Addendum 4

MA24- 5035 Interior Door Replacement at Homelands Senior Public School

**ADDENDUM No. 4
To BID DOCUMENTS FOR
HOMELANDS SENIOR PUBLIC SCHOOL
2420 HOMELANDS DRIVE, MISSISSAUGA, ON
INTERIOR DOOR REPLACEMENT
OHE PROJECT NO. 28769
MAY 2, 2024**

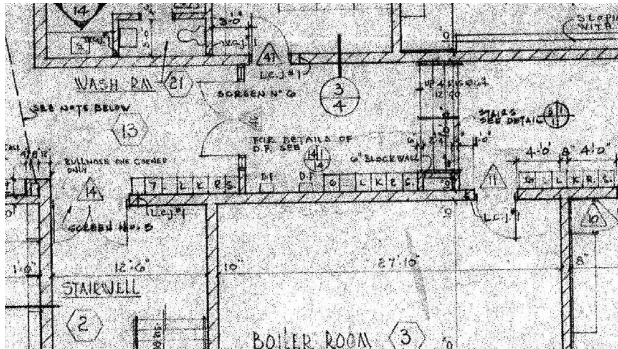
It looks like your table is missing frame painting scope for single doors. We suggest you to change the scope from "without frames" to" including frames" under scope #3, 4 and 5.

RESPONSE: In addition to our response to question no.1, in Statement A – Bid No. I it states "Repaint all frames and slabs in the original building that are not within the scope of replacement".

DRAWING TITLE:
ADDITIONAL DETAILS
(ARCHITECTURAL AND STRUCTURAL)

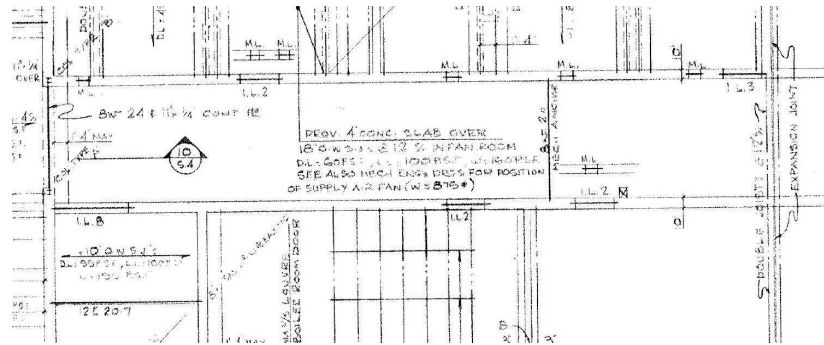
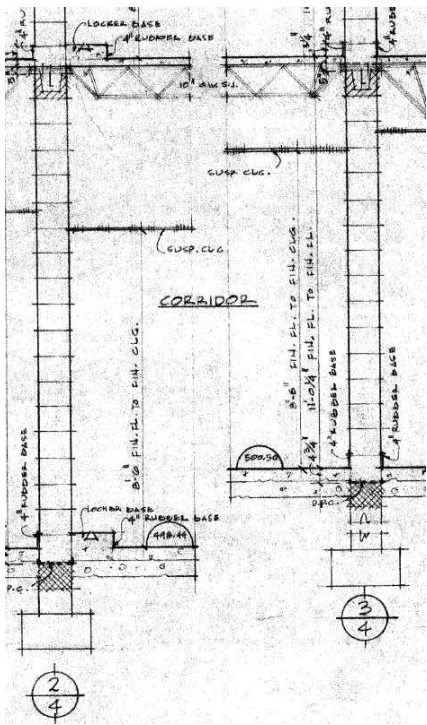
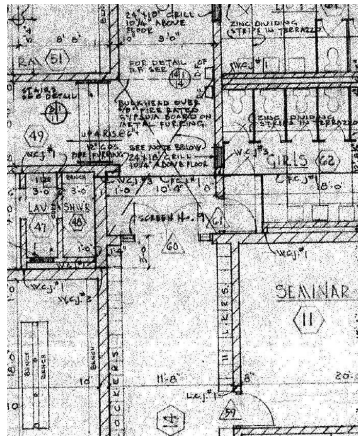
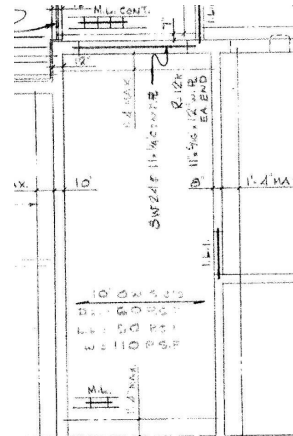
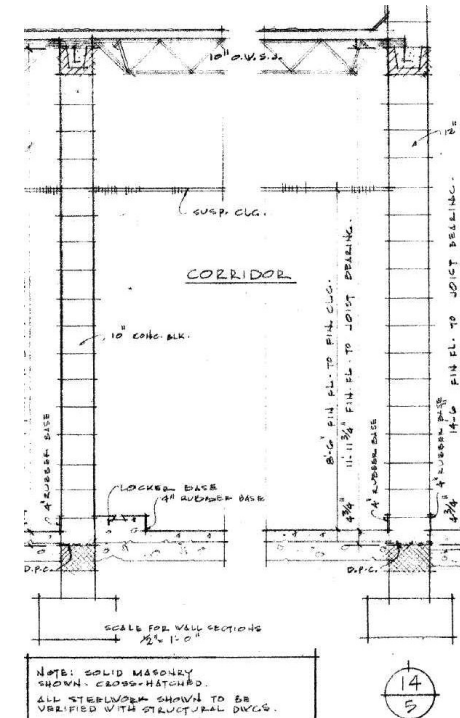
As the Scope of work states that, at a few locations Install additional structural reinforcing components above the ceiling to support new two interior door frames in the hallway; however, we don't have details regarding those, so could you provide the structural details on that?

RESPONSE: Refer to the attached additional (architectural and structural) details Drawing No. SK8.
